**IDAHO DEPARTMENT OF ENVIRONMENTAL QUALITY**

**ITB13-02HW**

**GROUSE CREEK REMEDY PROTECTION PROJECT  
SMELTERVILLE IDAHO**

**PRESUBMITTAL QUESTIONS, DEQ RESPONSE AND ITB ADDENDA**

(A) RETAINING WALL DETAIL  
 - SCALE: NTS

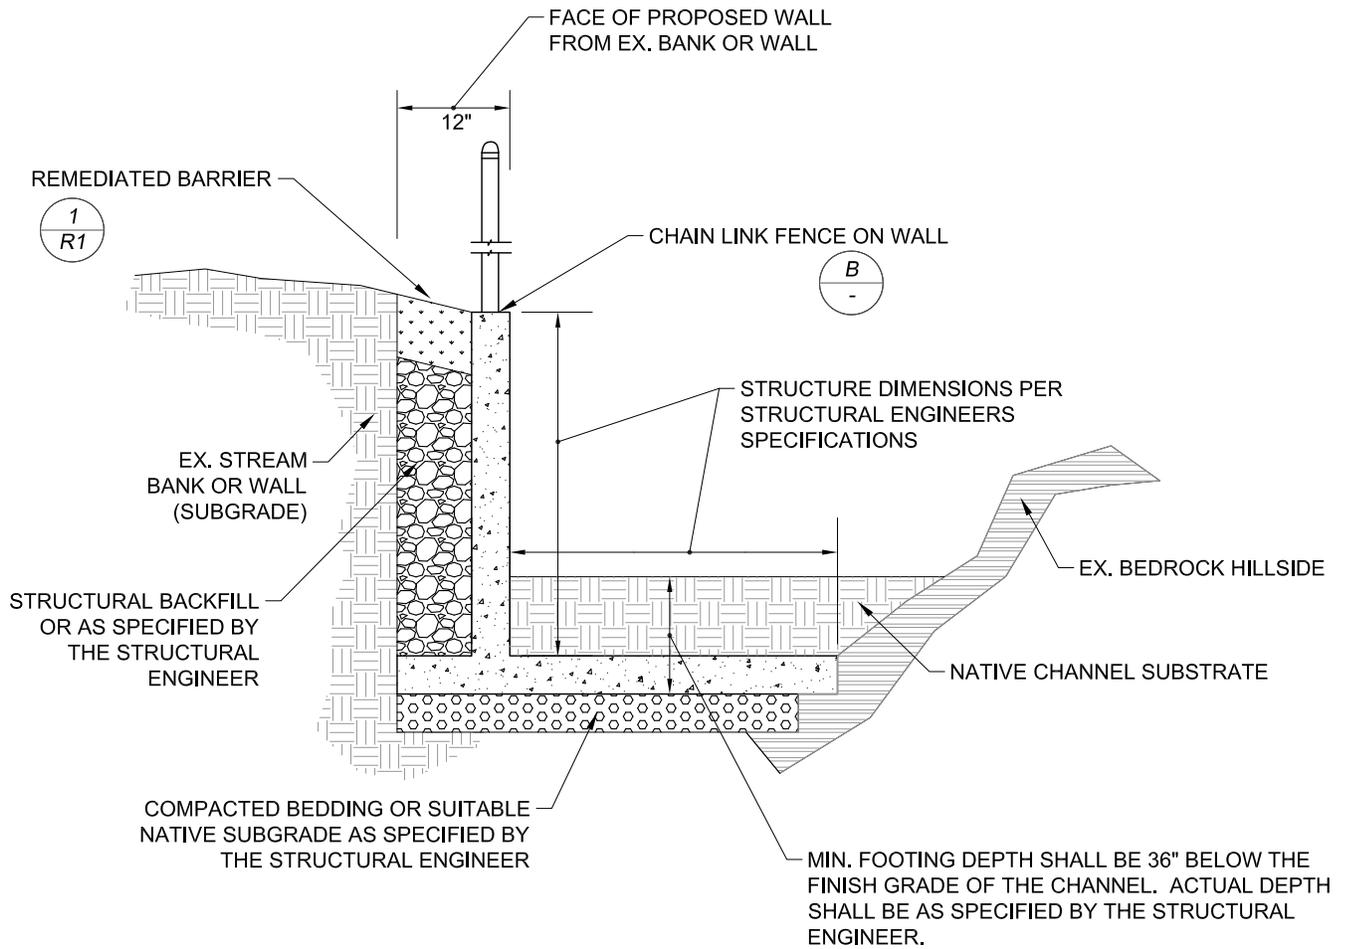
**5. Can the new concrete retaining wall from STA 11+70 to 13+23 be erected alongside the existing wall, instead of in the same location (as the existing wall)?**

**6. What is the minimum depth of the retaining wall footing?**

Answer: The face of the new concrete wall may be placed a maximum of 12 inches to the south of the existing wall. Refer to attached Exhibit A, which is a revision of Detail A on Sheet D9 of the drawings.

Answer: The underside of the footing shall be a minimum 36 inches below the finish grade of the channel bed. The footing shall have a minimum of 24 inches of native stream bed material cover. The actual depth in relation to the design of the system shall be verified by the structural engineer certifying the shop drawings, and increased as necessary. Refer to attached Exhibit A, which is a revision of Detail A on Sheet D9 of the drawings.
